# 802.3dm PHY Nomenclature/Definitions Proposal

William Lo

November 10, 2025

# Fig 201-2

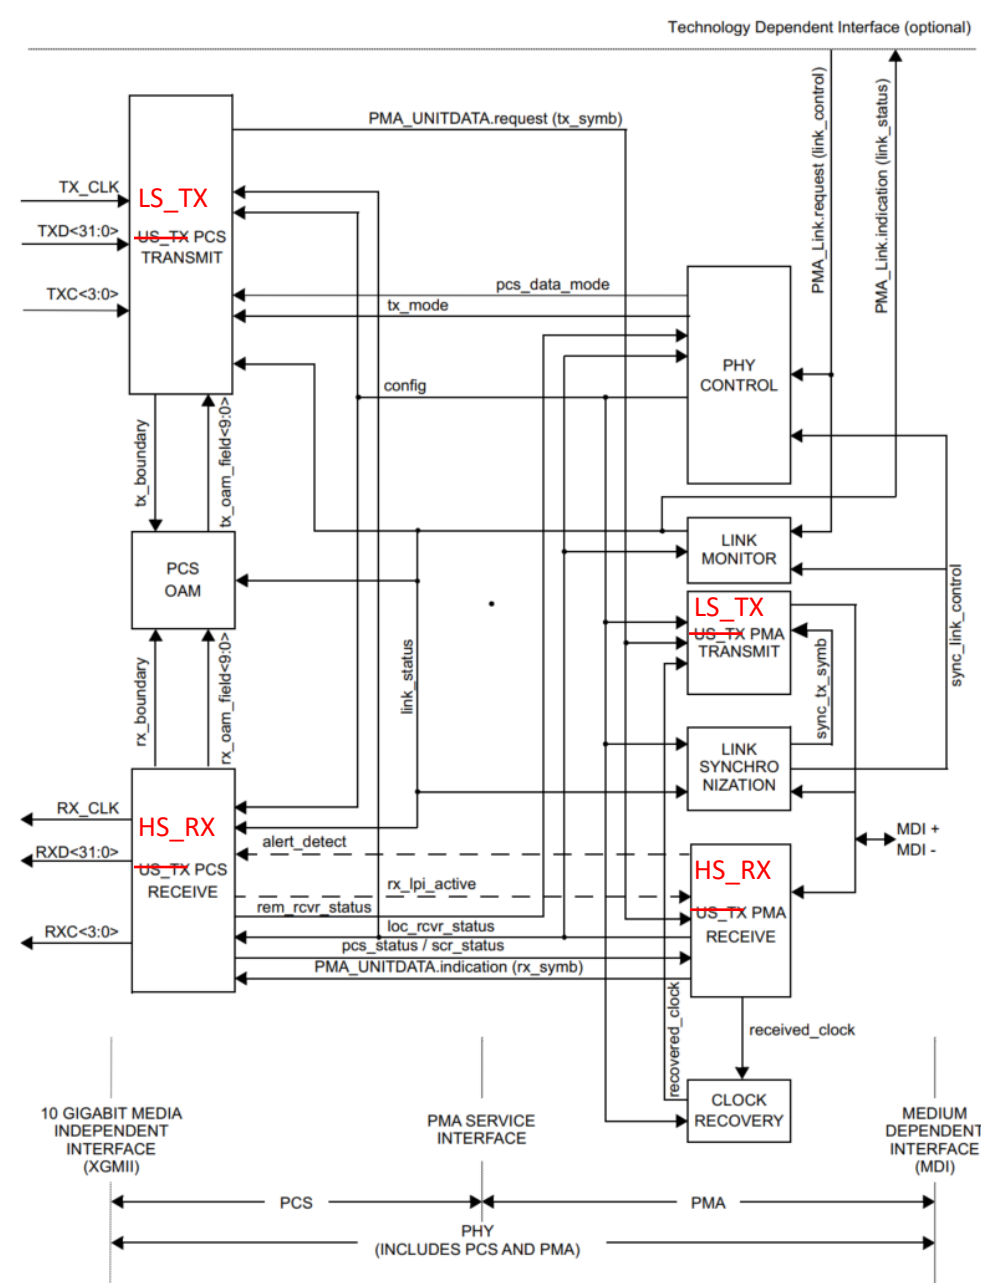
- HS\_PATH PHY\_S HS\_TX to PHY\_D HS\_RX (replaces DS\_TX in 201.1.1)
- LS\_PATH PHY\_D LS\_TX to PHY\_S LS\_RX (replaces US\_TX in 201.1.1)

- For the most places can replace DS\_TX with HS\_PATH and US\_TX with LS\_PATH
- There may be exceptions where HS\_TX, HS\_RX, LS\_TX, LS\_RX, PHY\_S, PHY\_S may be more appropriate.
  - i.e. 201.8.2.1.1 where phy\_role enum DS\_TX should be PHY\_S and US\_TX should be PHY\_D
- Titles in 201.2 and 201.3 should be tied to PHY\_S and PHY\_D and not HS\_PATH and LS\_PATH.
